FINAL PLAT

BENTLEY MEADOWS

RE: SUB 2001-17 -- One-Step Final Plat of Bentley Meadows Addition

STAFF REPORT

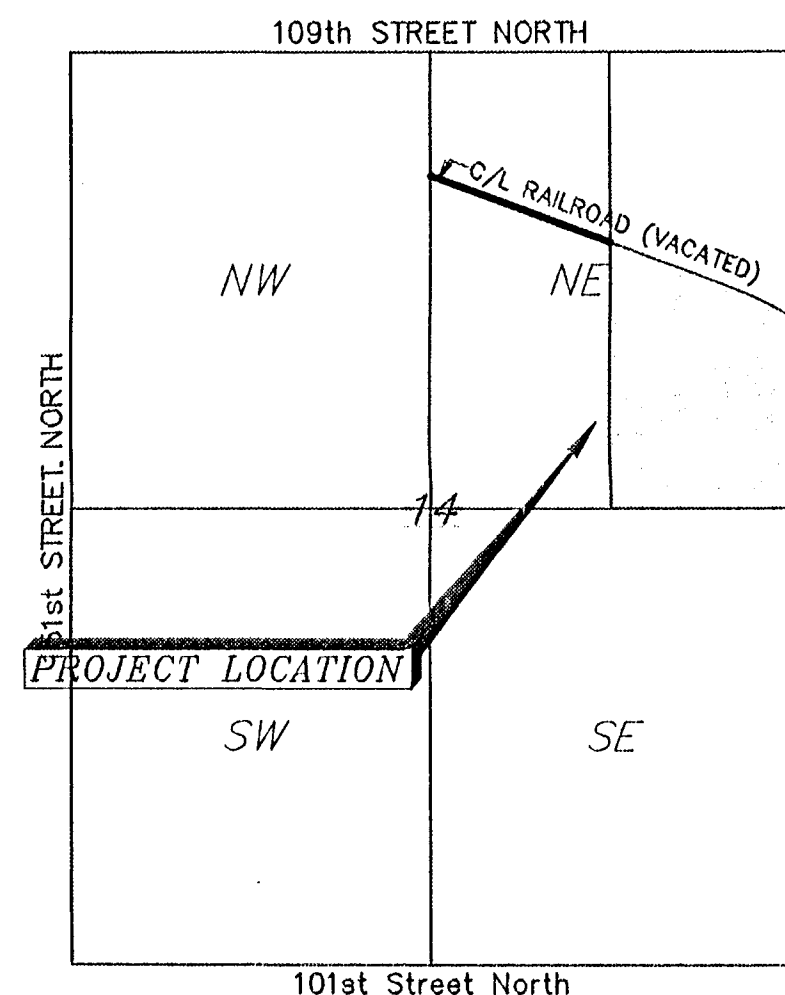
- D. The plat shall be corrected to reference complete access control along the plat's frontage to 135th St. West. The final plat shall reference the access controls in the plat's text.

- H. County Fire Department needs to comment on the plat's street names. Hunter needs changed to Aurora Ct. Emily needs changed to 105th St. N. Autumn needs changed to 107th St. N.

- N. On the final plat, the MAPC signature block needs to reference "Bernard A. Hentzen, Chair".
- O. County Surveying has advised that property corners to be installed need shown.

- P. The centerline of Emily Street and Autumn Street needs located along the section line.
- Q. The dimension on the east line of Lots 9 and 11, Block 2, needs added.

- R. Block 1 has duplicate Lot numbers, and needs renumbered.
- S. Block 2 needs labeled.
- T. The curve data on the north line of the subdivision needs shown on the face of the plat.
